# PIONEER MEADOWS

### MASTER DEVELOPEMENT PLAN

Subject: Pioneer Meadows Master Development Plan (AP 1141950)

### Map of Area 1

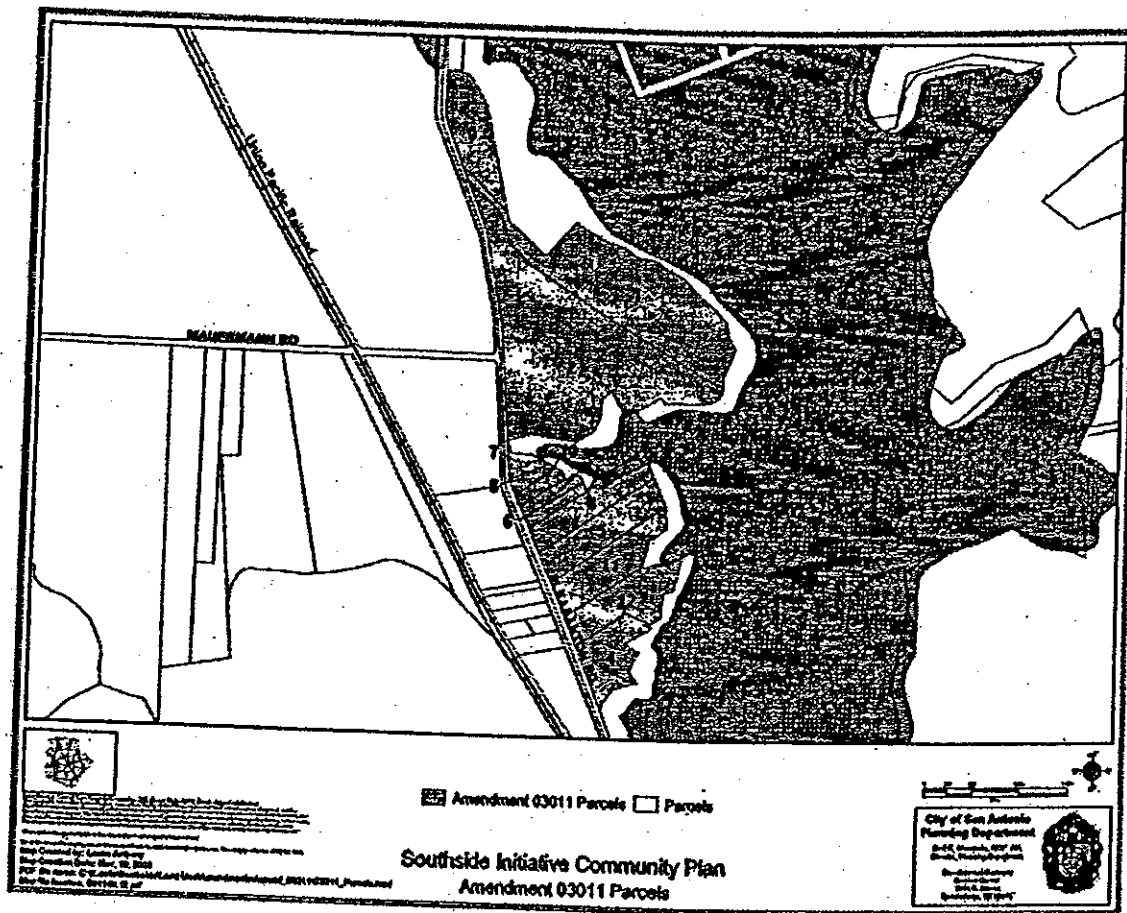
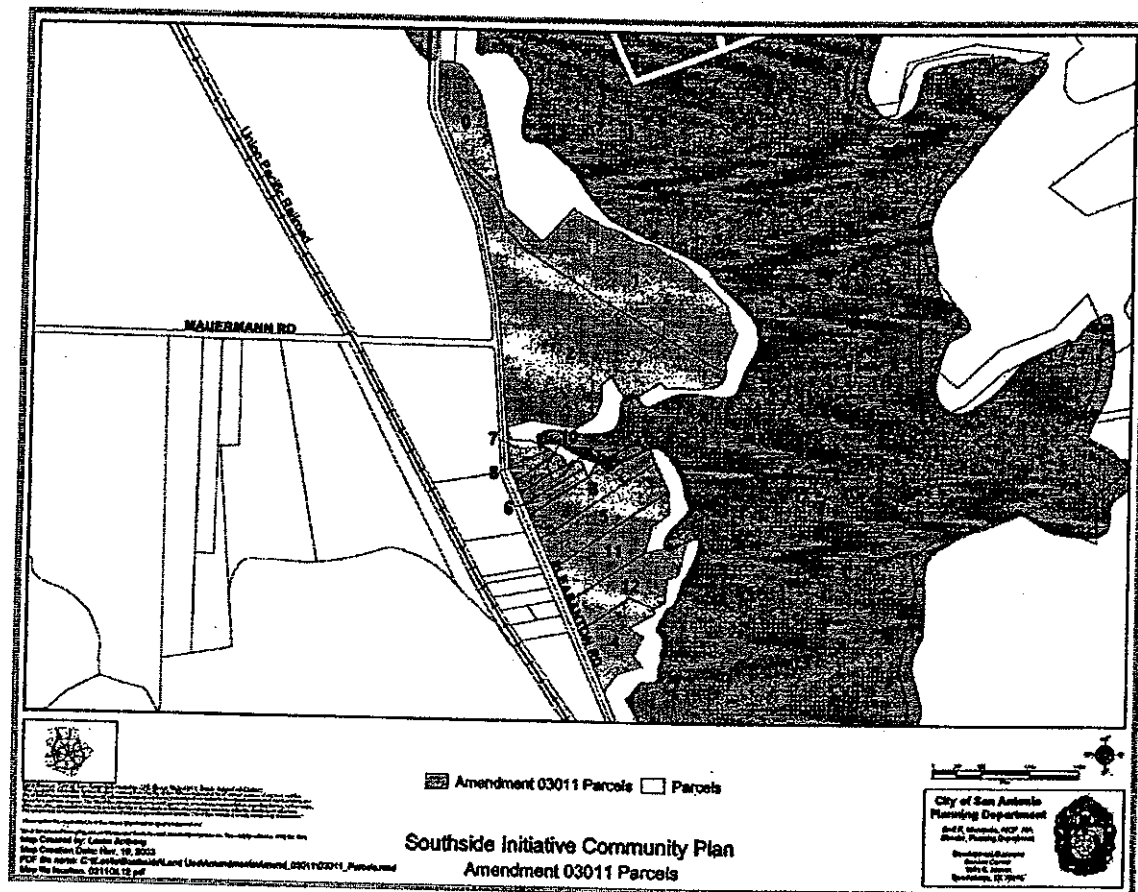
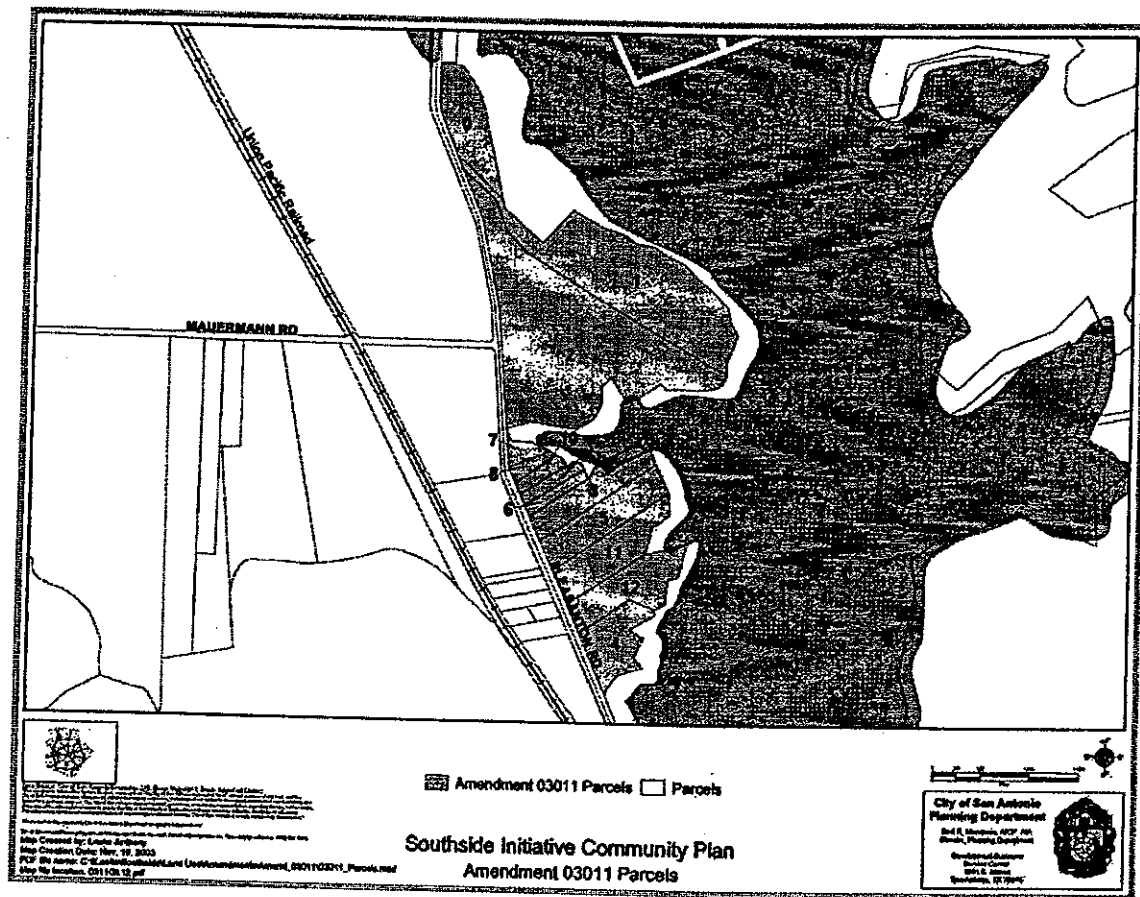
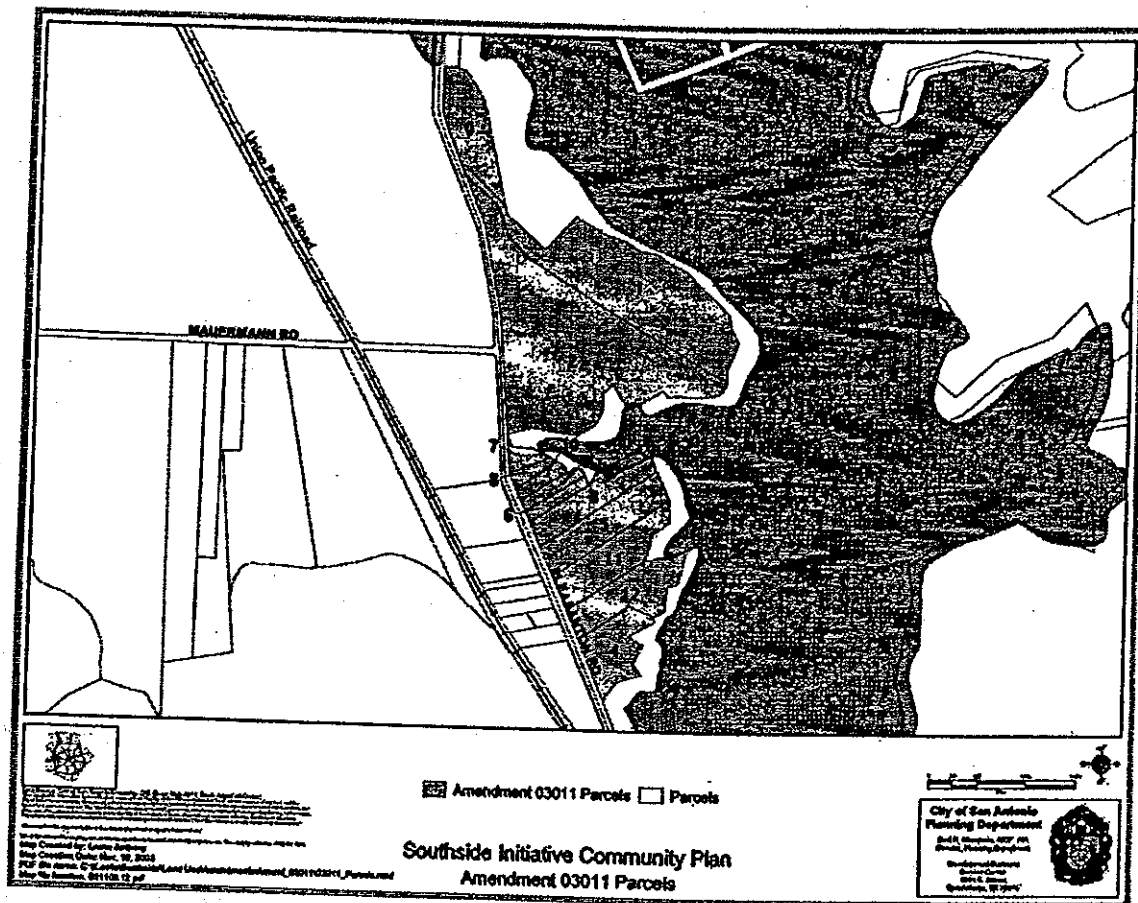
Your proposal lies in the IDC district as shown on exhibit "A". (See attachment)  
Please note that you can always resubmit a new application after the IDC have expired.
